#### PLANNING COMMISION MINUTES

#### APRIL 19, 2022

To: City of Chelsea Planning Commission From: Julia Upfal, Community Development Director, City of Chelsea Subject: Combined Preliminary and Final Site Plan- Heydlauff's Expansion Date: April 16, 2022

This letter is to provide feedback on the 4 plan sheets and 5 architectural plan sheets submitted to the City of Chelsea for the expansion of Heydlauff's showroom, including a 592 SF building addition, located at 107, 107.5, 109, and 113 N. Main Street, Chelsea, Michigan 48118. The Planning Commission shall review these plans with consideration of the following comments from the Planning and Zoning Administrator.

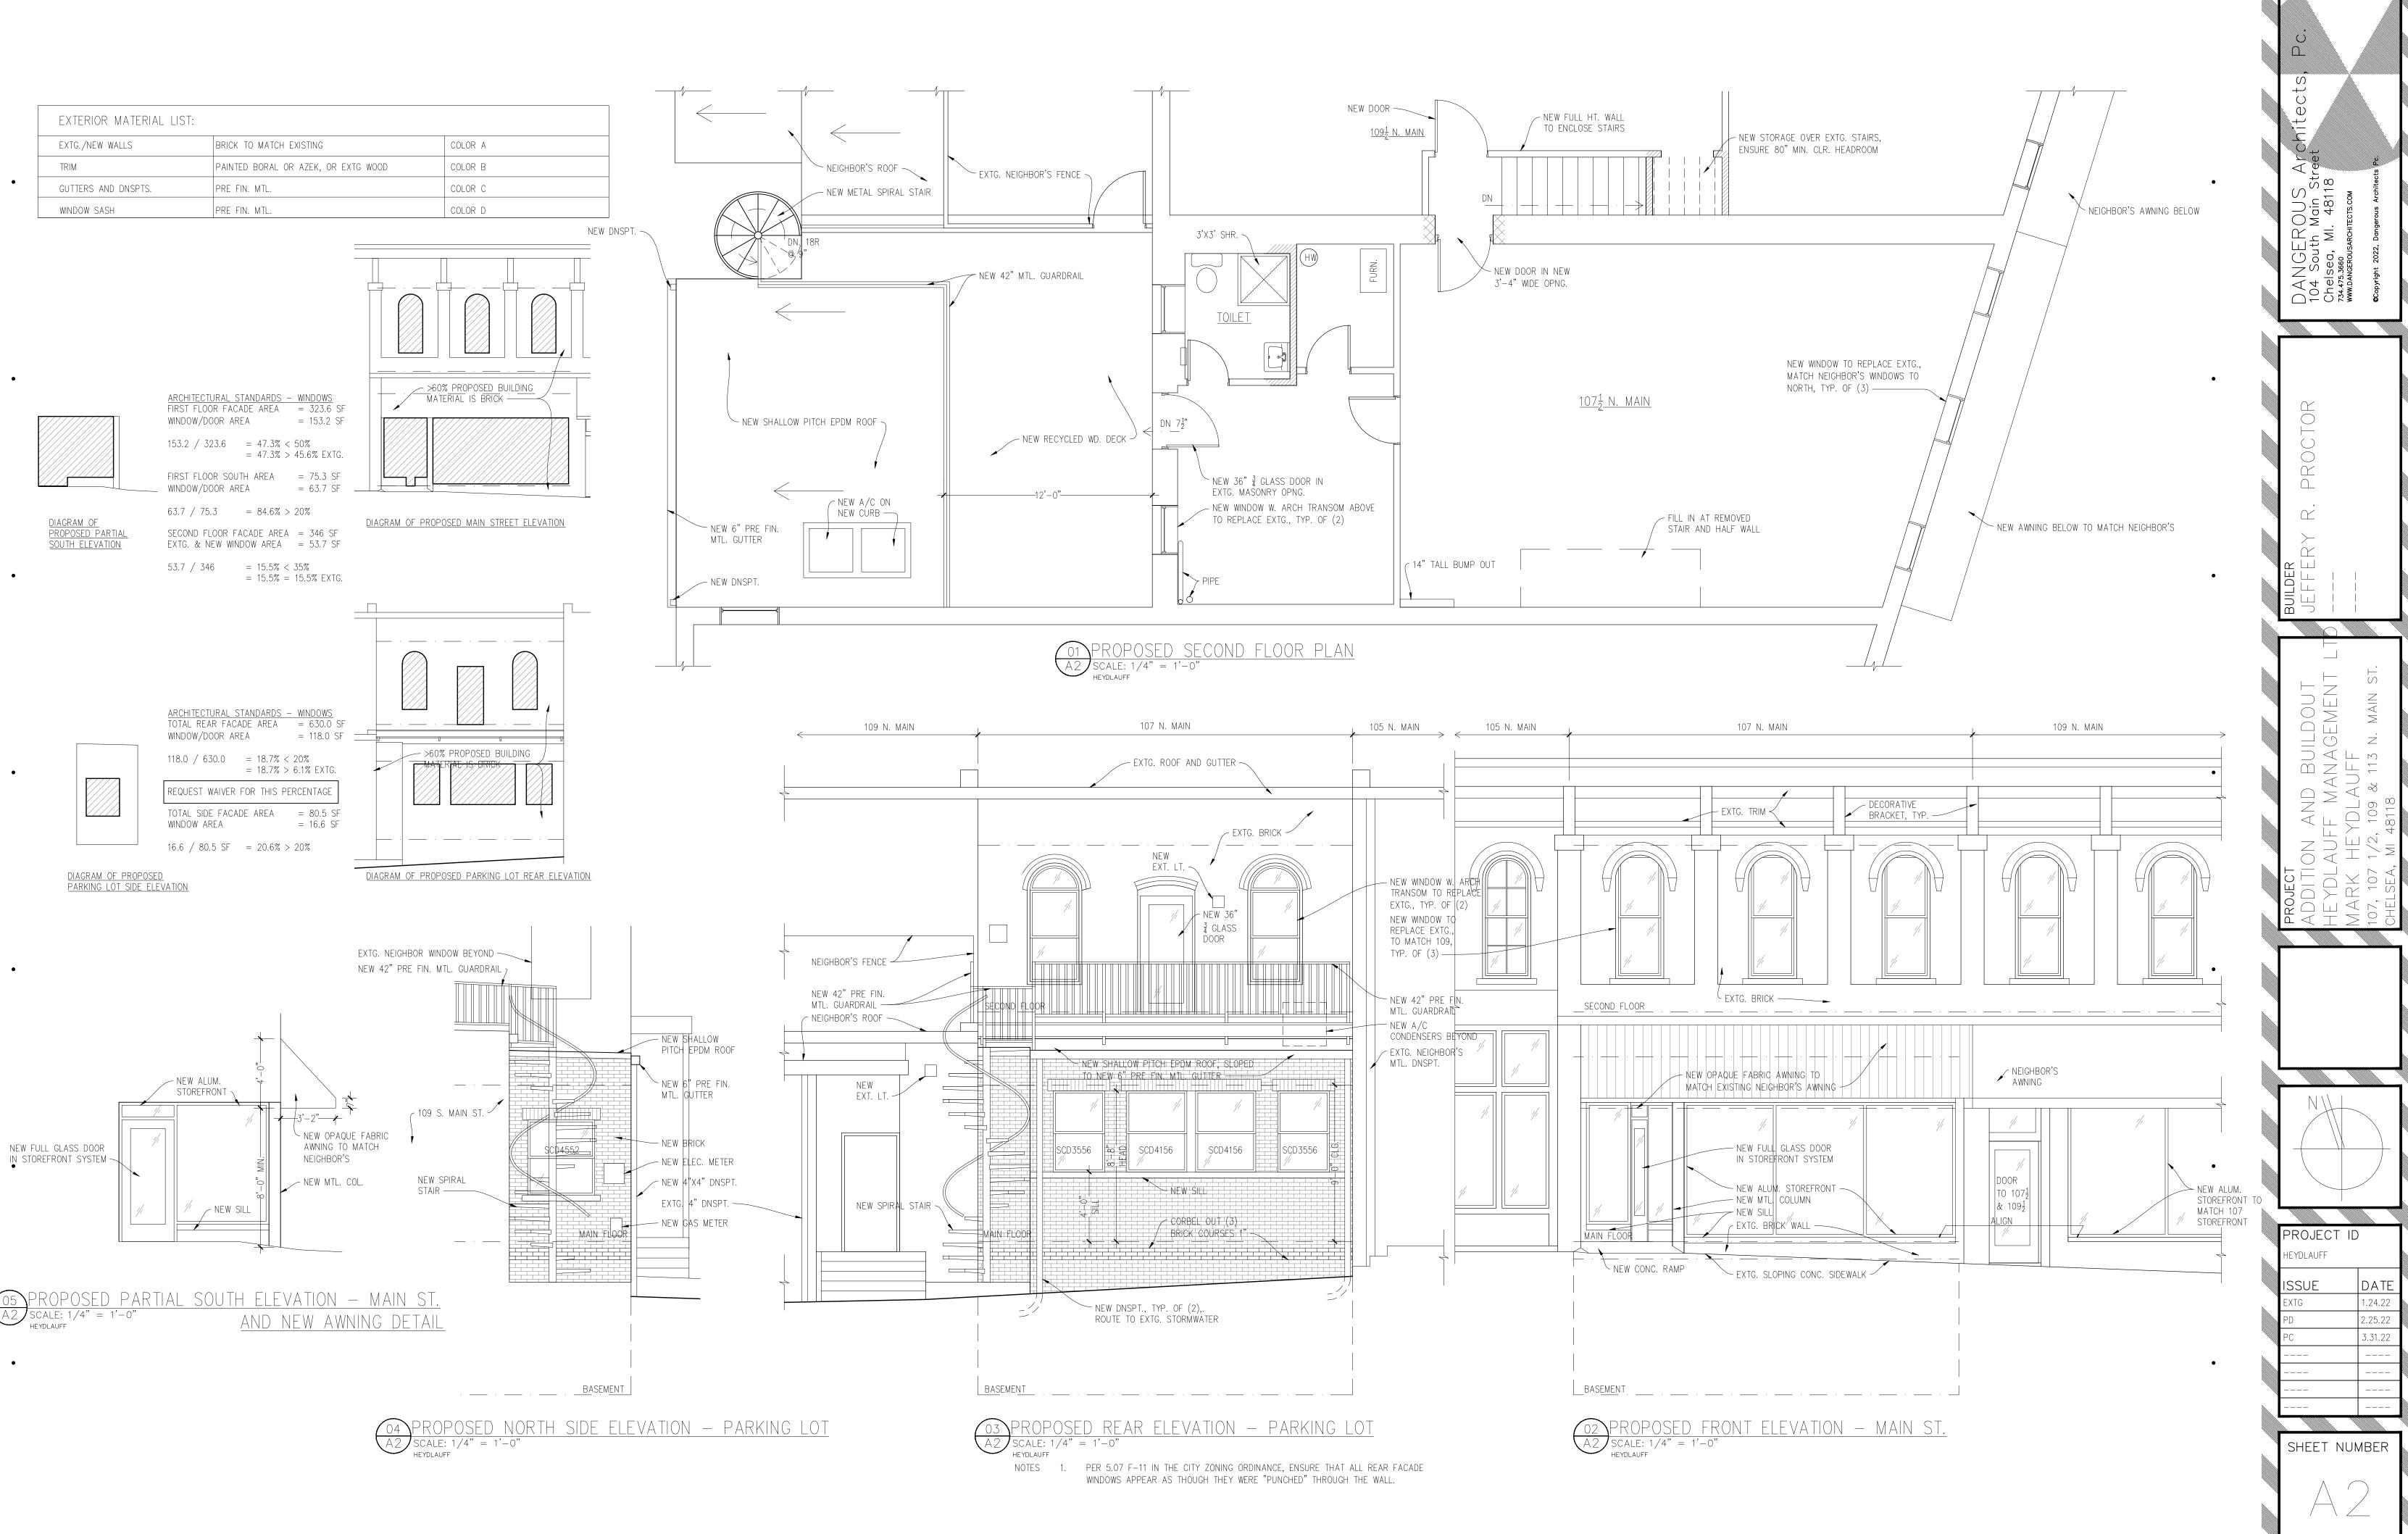
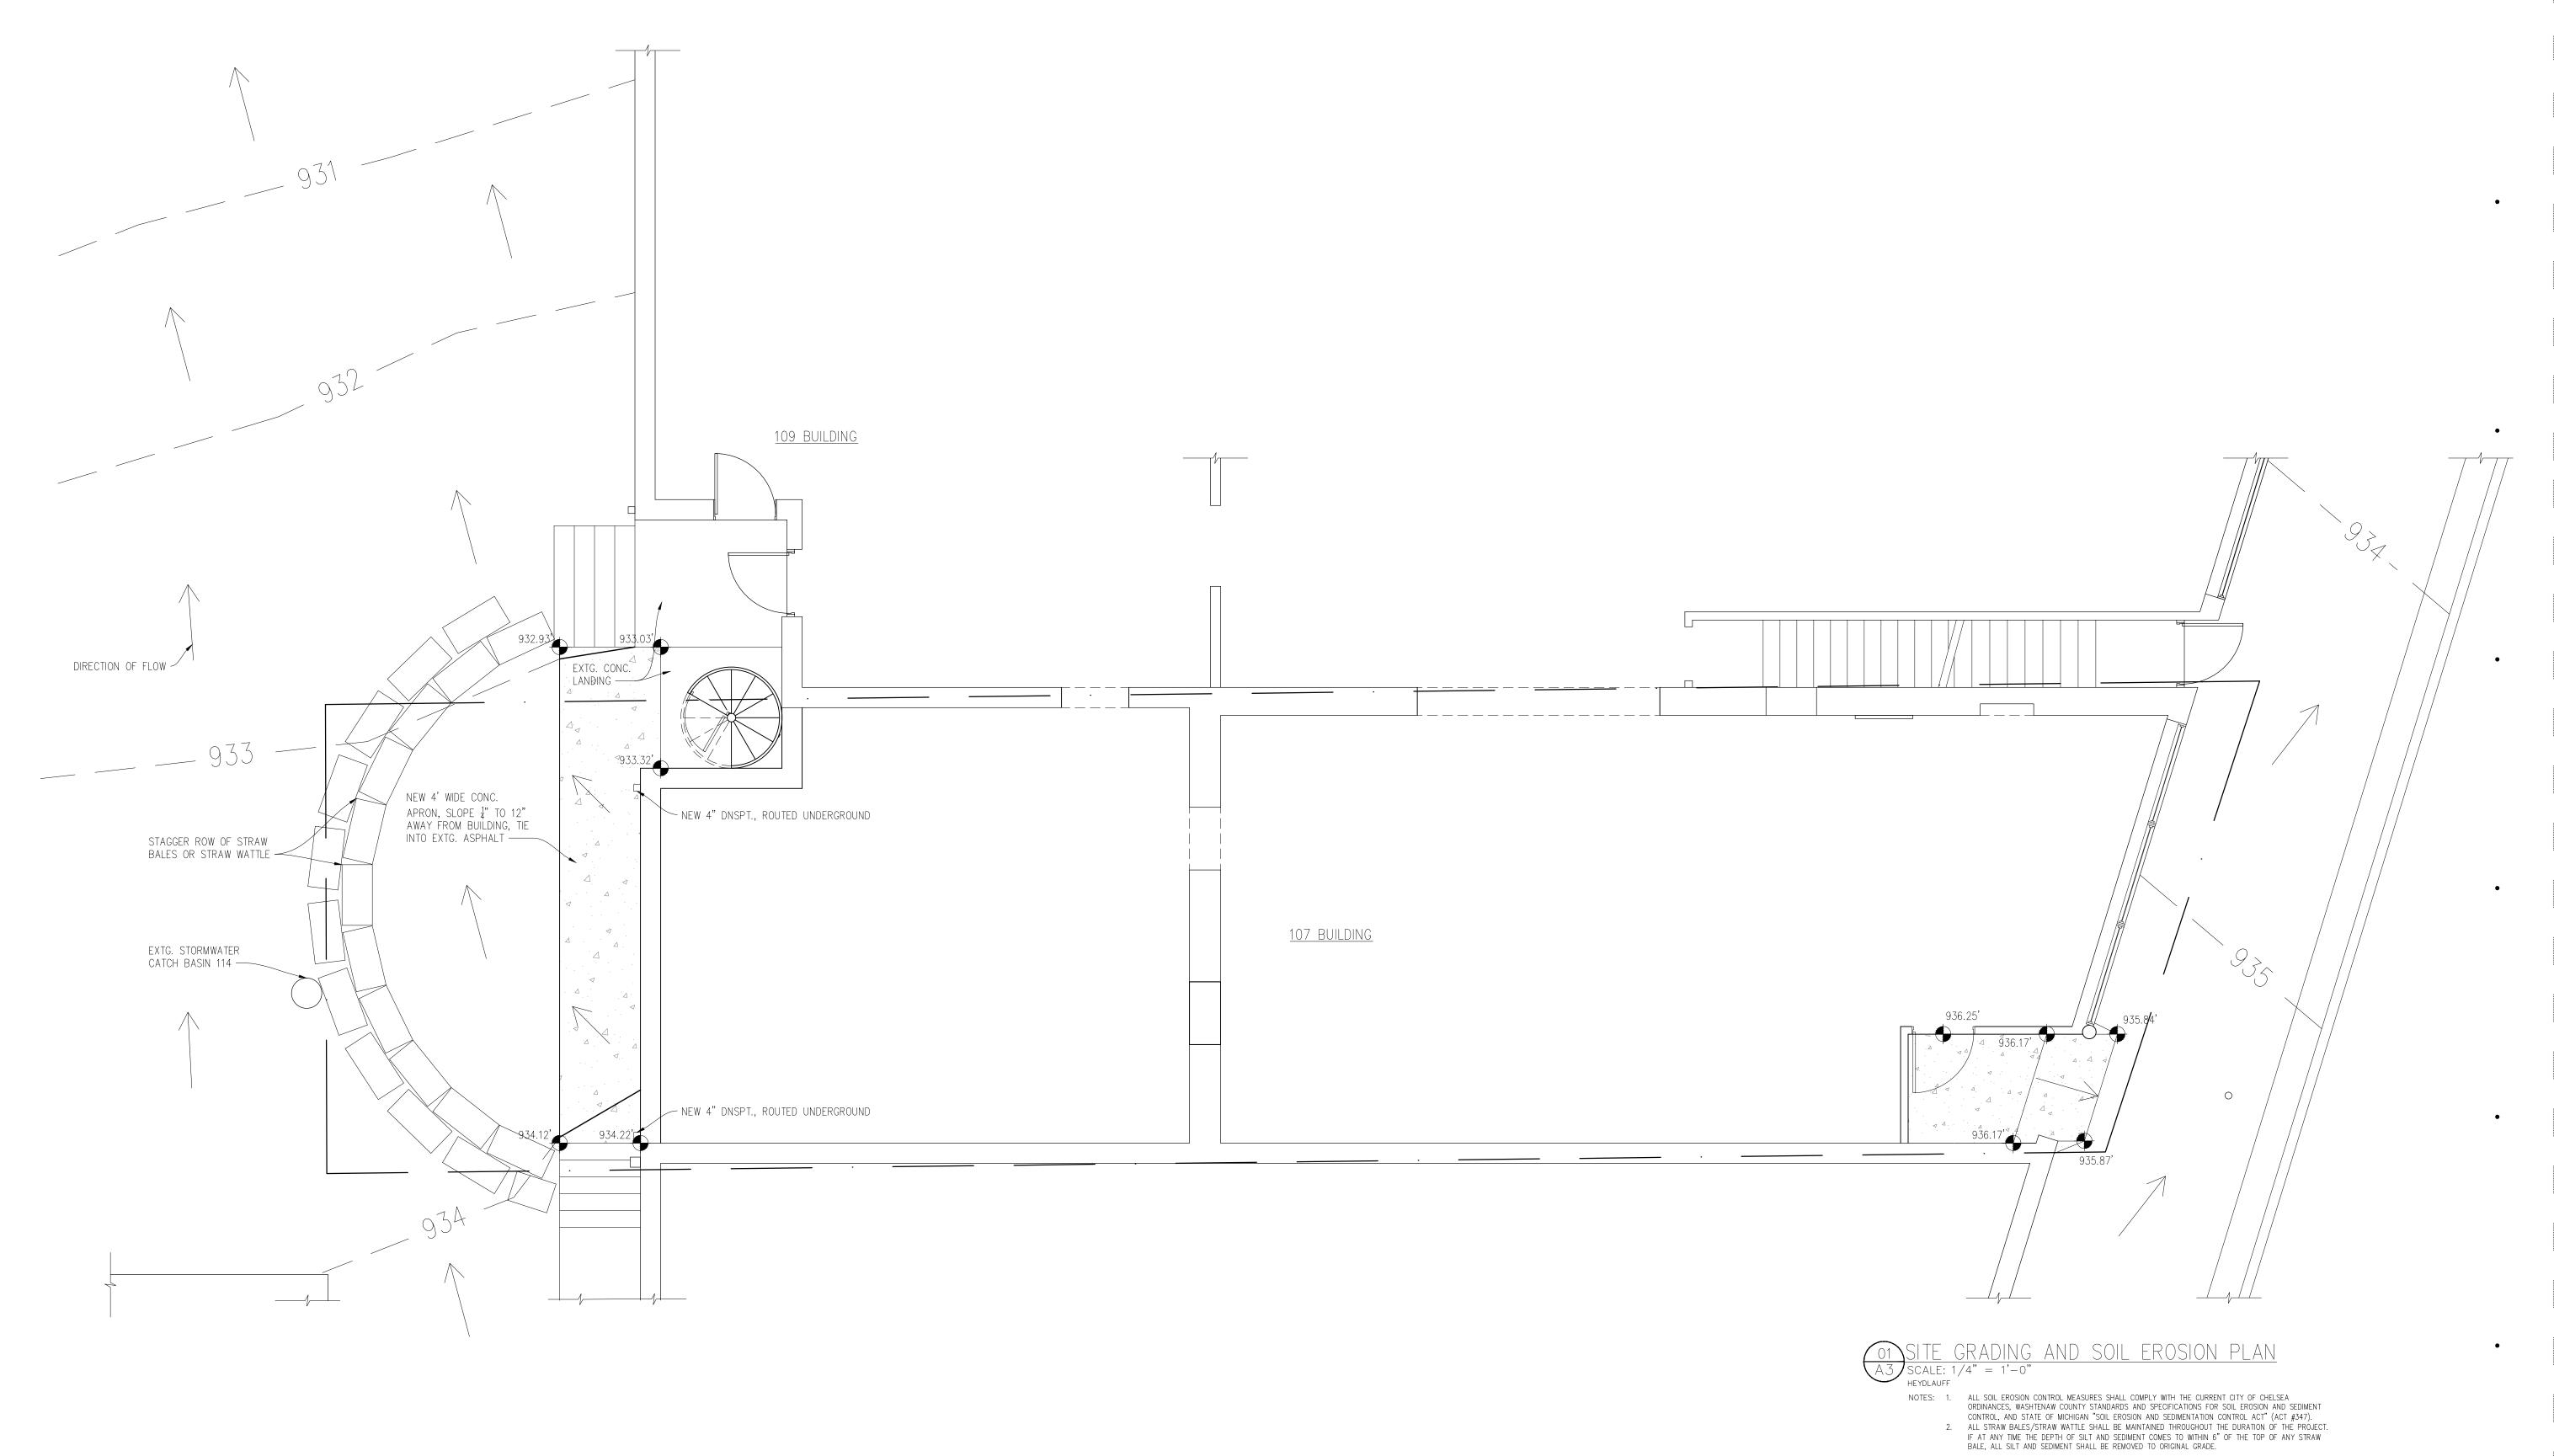
- 3. On Sheet A2, the applicant includes a waiver request for a reduction in first floor rear façade windows. The Planning Commission shall review this request, consistent with Article 5.03.

- 5. On Sheet A2, the applicant should include a note which explains whether new brick will match existing, consistent with Article 5.06 A-2 "Unified Storefront Design."

- 9. On Sheet A2, the applicant includes waiver requests for front façade windows, however, the proposed windows have the same level of compliance as what as previously there. Therefore, a waiver request is not required and this note should be removed.

- a. We recognize the Planning Commission's input and believe that the new addition is compatible with the existing building and the ordinance.
- 11. Windows on the rear façade shall be recessed into the façade wall to appear as though they were "punched" through the building façade (5.07 F-11)

13. Awning details should be provided to show compliance with Article 5.08C.

- a. This note has been removed from the front façade second floor windows.
- 10. The Planning Commission shall provide feedback on whether the proposed spiral staircase and guardrail are compatible with the existing building (5.07F-12).

- a. New rear windows will comply with this ordinance requirement and a note has been added to Sheet A2. A typical window detail used for both historic and new construction is the window frame extends onto the 4" brick by 1", meaning the outer edge of window frame is

3" in back of the outer brick plane which will provide the nonflush/punched look.

- a. The previously approved awning from 109 N. Main will be visually extended across the 107 N. Main building with a new awning to match 109 N. Main. Awning details are provided on drawing 05 on sheet A2.
- 14. Soil Erosion and Sedimentation Control Plan must be approved by the Chelsea Area Construction Agency as a condition of approval.
  - a. We recognize that soil and erosion control must be approved by others. Please see 01/A3.
- 15. The applicant modified their draining plan to connect to an existing 6" drain in the rear of the building. The Department of Public Works is concerned this 6"
